SHOREHAM NUCLEAR POWER STATION

SNRC-1141

Fire Protection
Shoreham Nuclear Power Station - Unit 1
Docket No. 50-322

Reference 1: Letter NRC (Thomas T. Martin) to LILCO (J. D. Leonard) dated 12/21/84 forwarding Inspection Report 84-46

LILCO
DRAWING
NUMBER **M-10661-12**

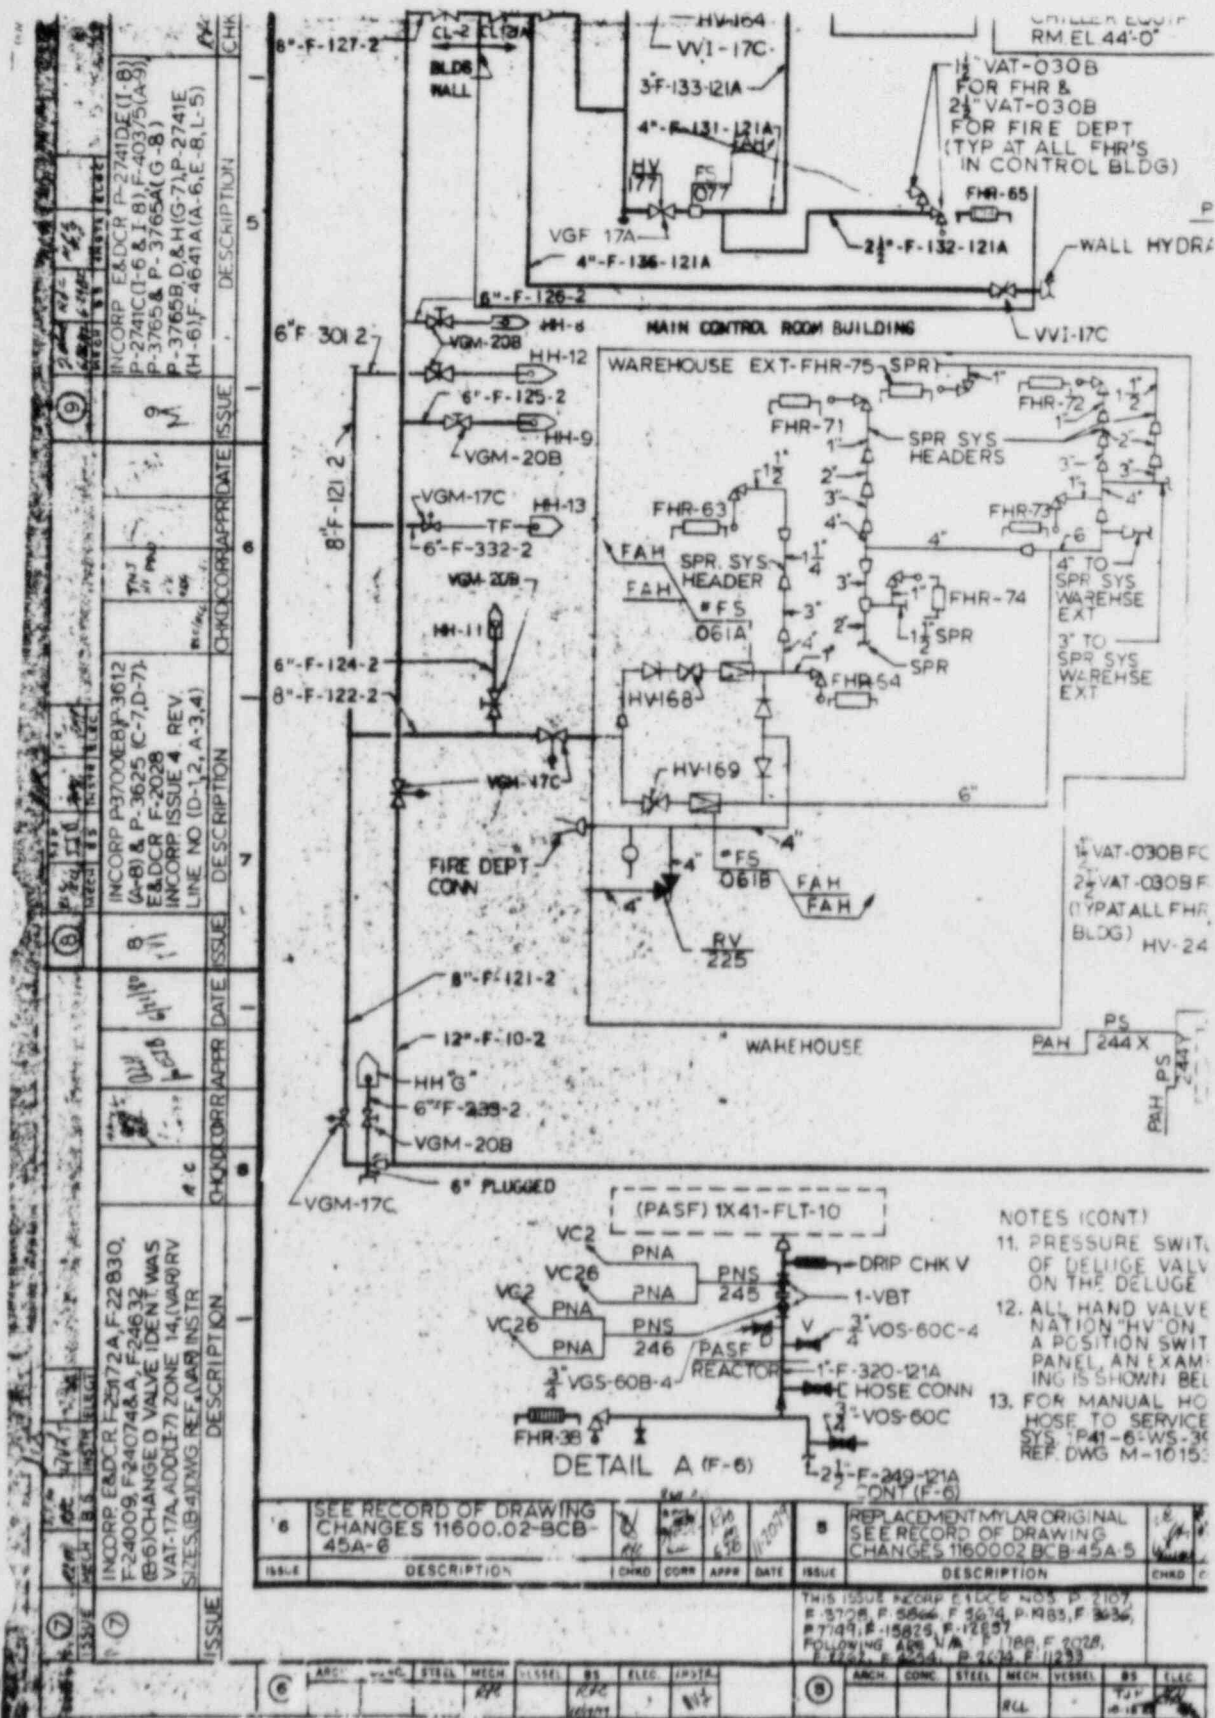
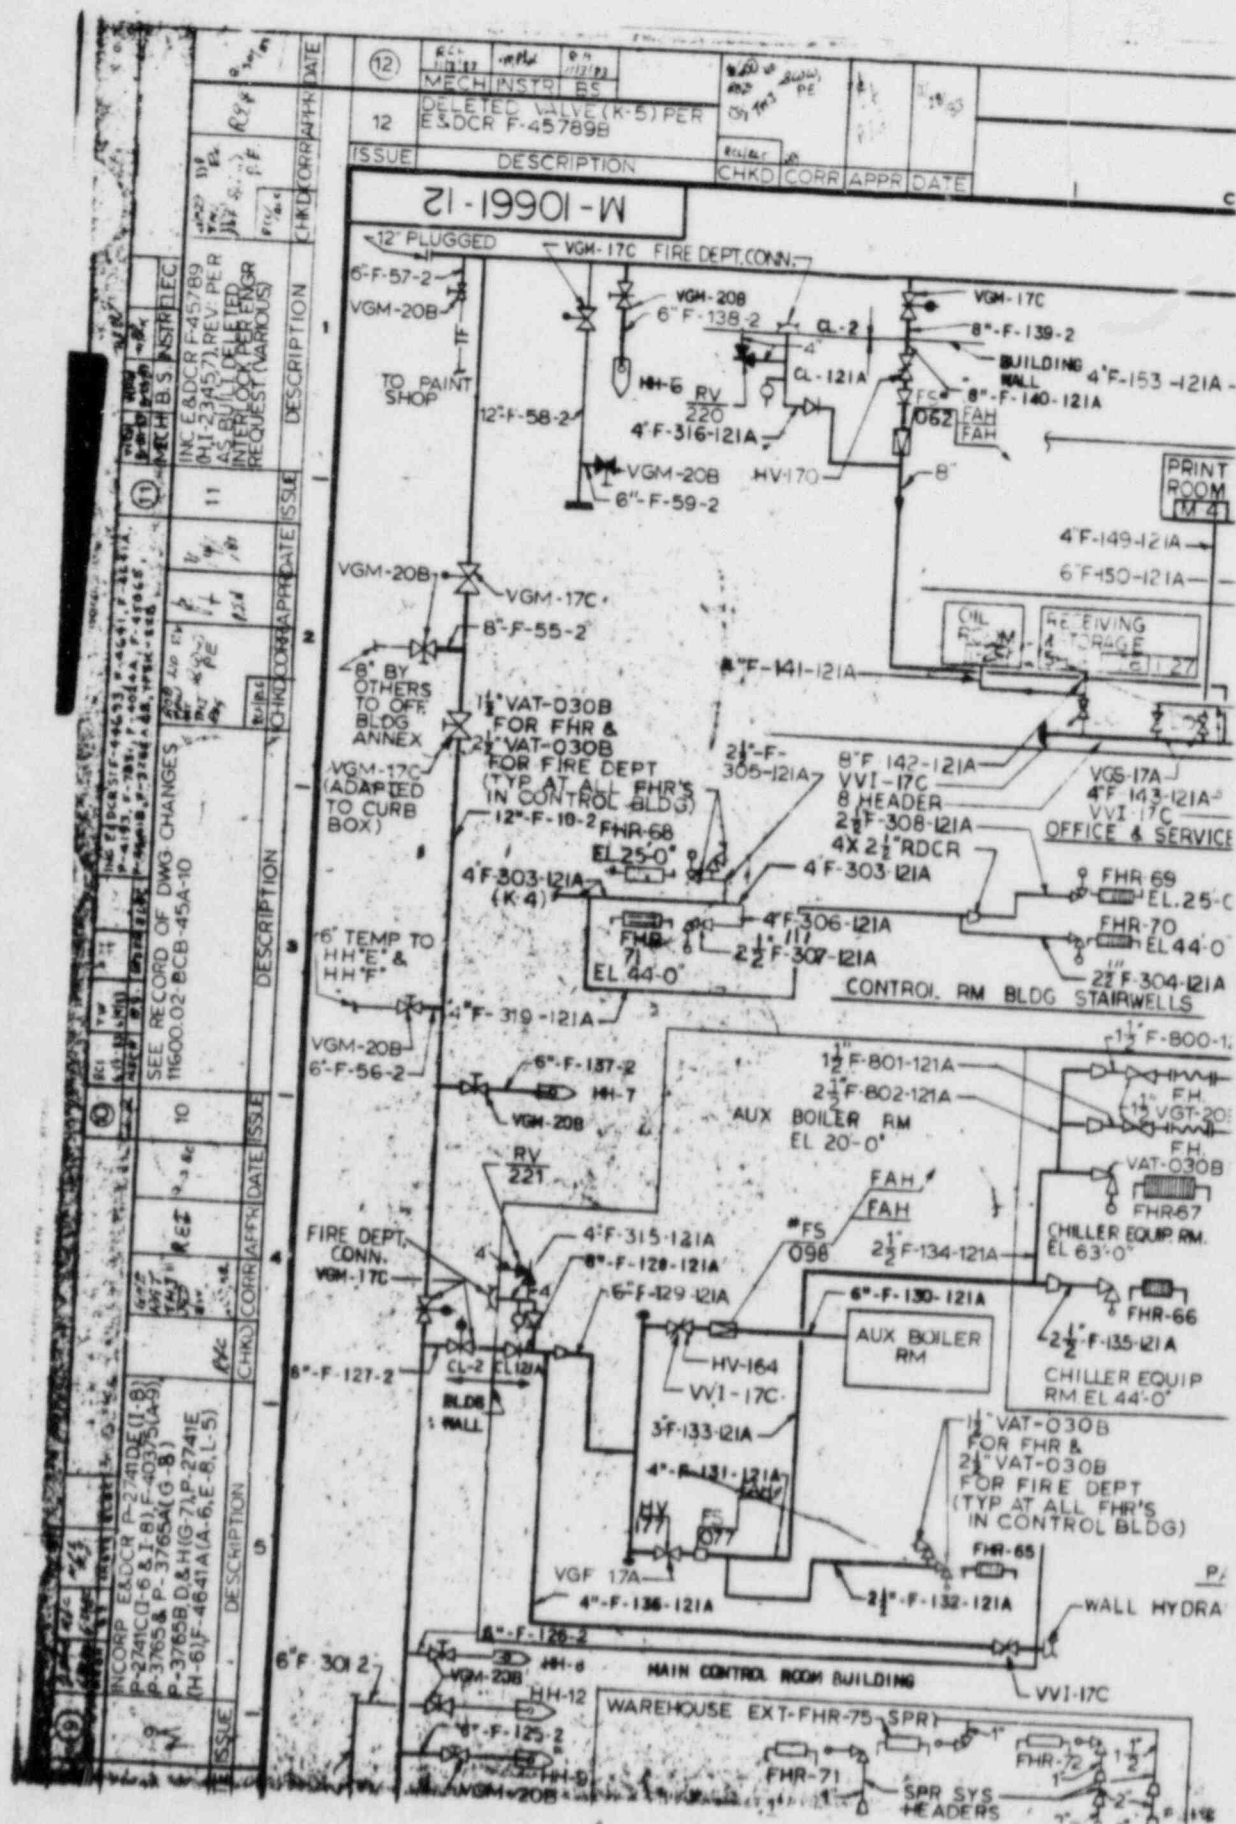
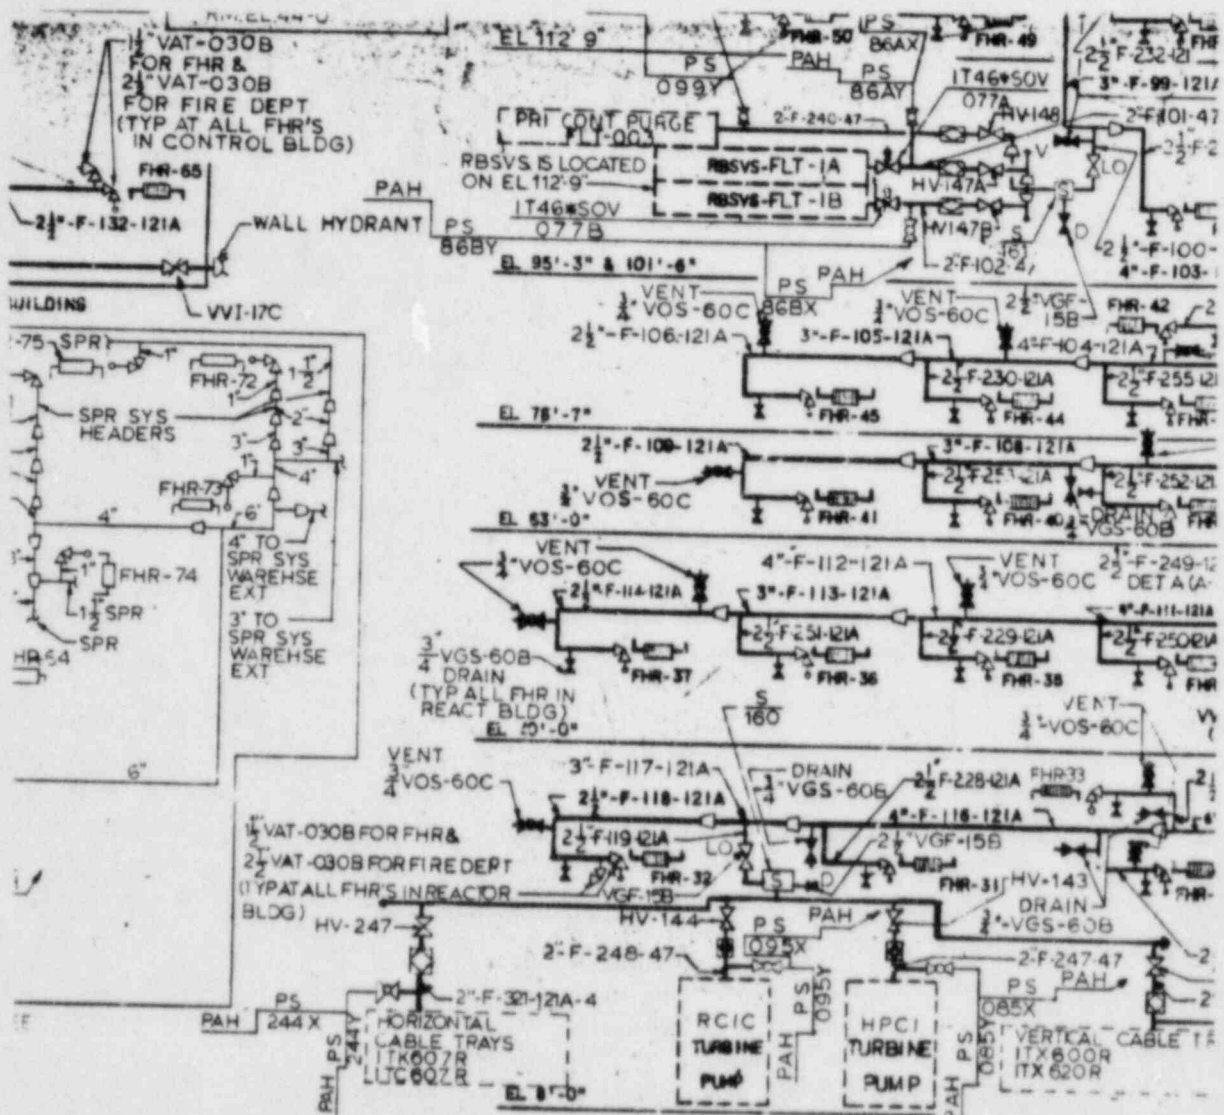
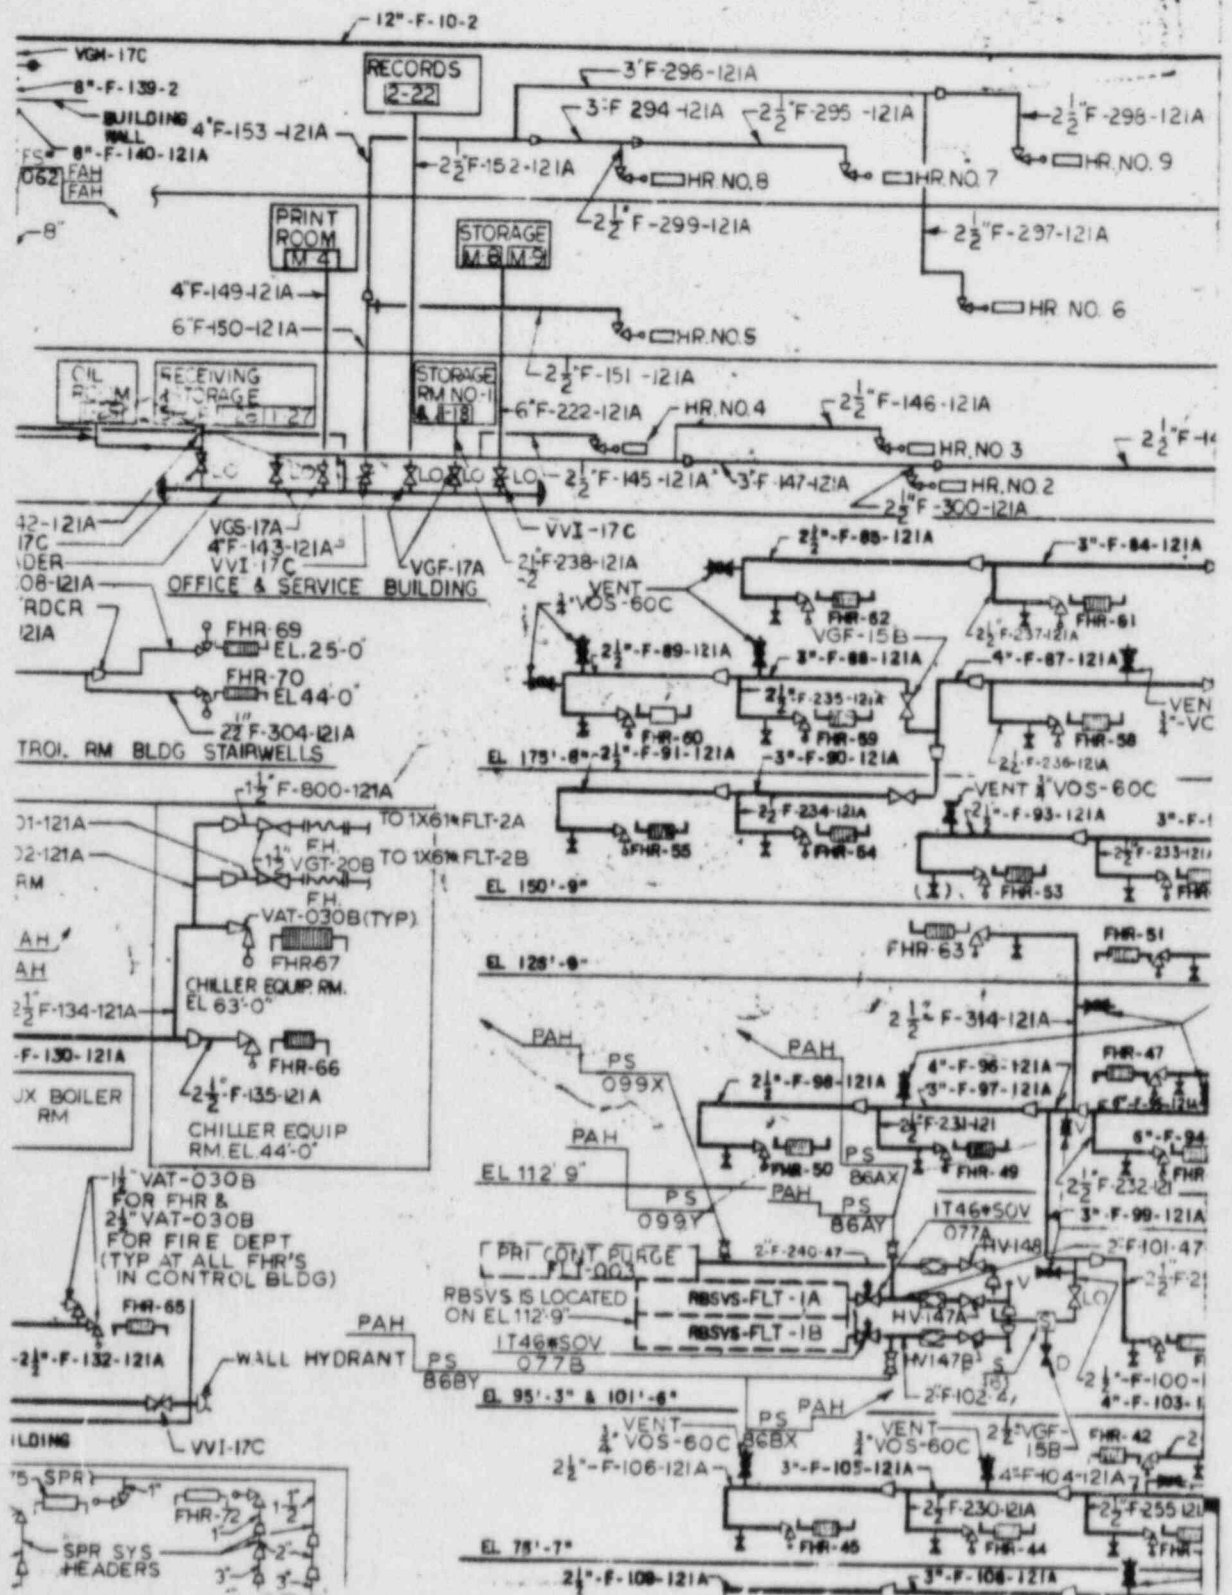
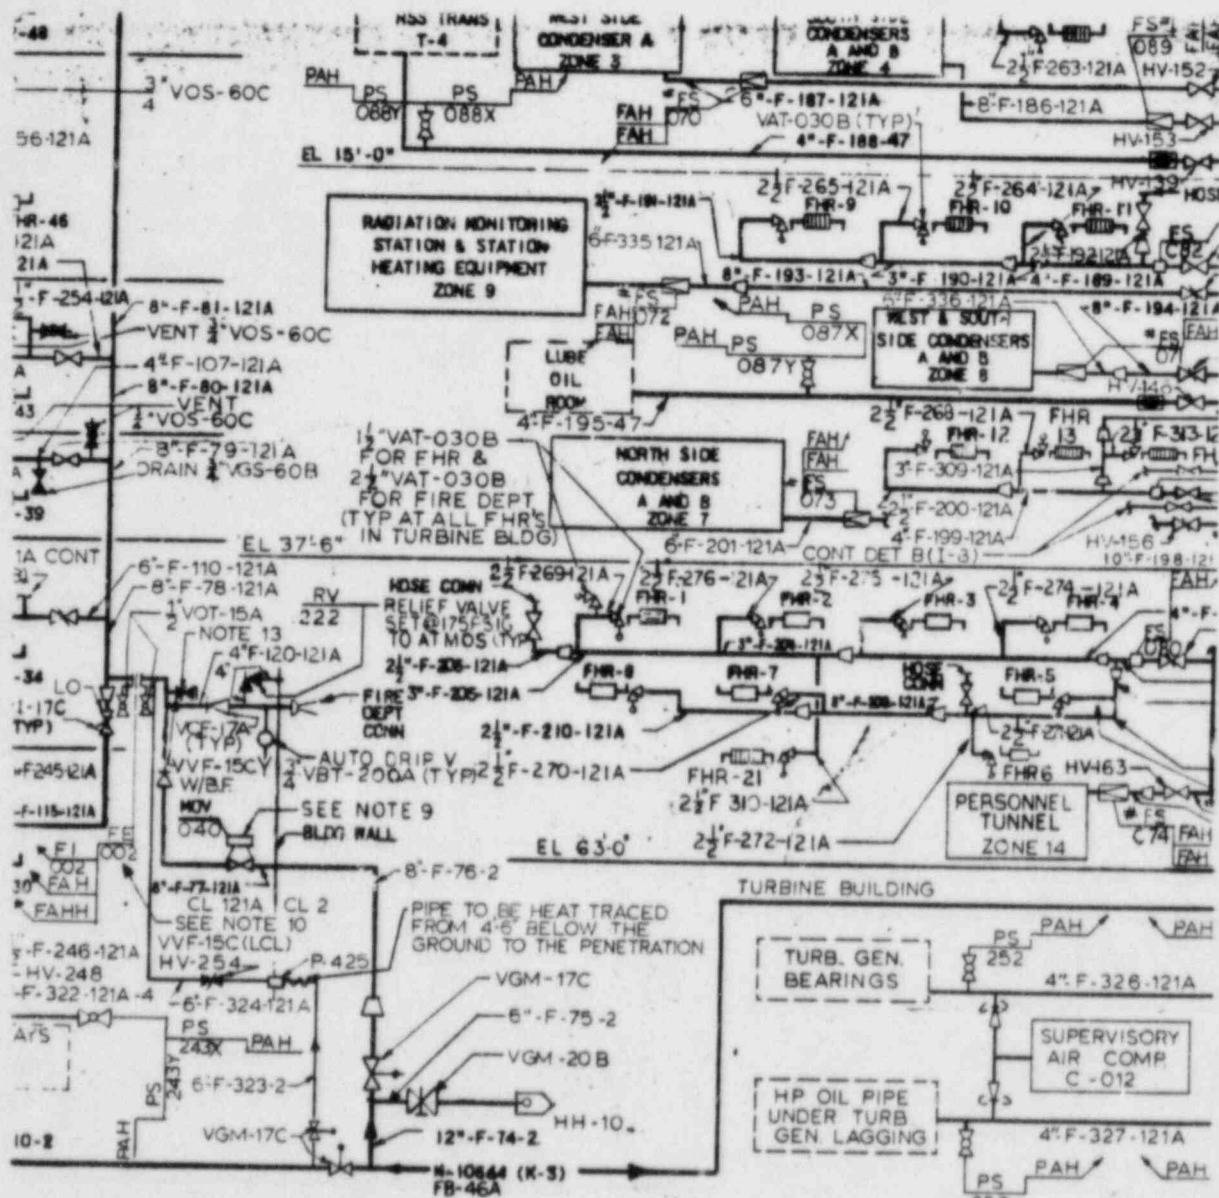
Unresolved Item 84-46-14 - Single Header in the Reactor Building

Branch Technical Position 9.5-1 Appendix A requires that a single failure not impair the fire suppression system. LILCO complies with the BTP. With respect to the single header in the Reactor Building, LILCO has utilized the guidance of MEB-1 in determining that the postulated pipe failure for this moderate energy system would result in a crack producing a leakage of 165 gpm. Such a failure would not impair the fire suppression system in the Reactor Building since each fire pump has a rated capacity of 2500 gpm.

The single header configuration utilized at Shoreham was inspected and reviewed by the NRC during the FSAR review process (1979-1980). As a result of a staff question (FHAR Question 1), a redundant feed to the Reactor Building was installed. With this modification, the Staff accepted the design of Shoreham's fire header for the Reactor Building.

A copy of drawing M-10661, Rev. 12, "Water Fire Protection System" is enclosed, showing the water suppression system in the Reactor Building. Shoreham Technical Specifications require that if the fire suppression water system becomes inoperable, a backup fire suppression water system must be established within 24 hours. From the enclosed figure it can be seen that certain non-postulated circumferential breaks in the Reactor Building could be isolated and backup suppression established via hose reels or extinguishers. Depending on the location, certain other non-postulated breaks could render the fire suppression system temporarily inoperable. If backup suppression could not be established, LILCO would bring the plant to the shutdown condition.

The FSAR has always contained the single header configuration. The NRC accepted this configuration and LILCO believes that a backfit is not justified.
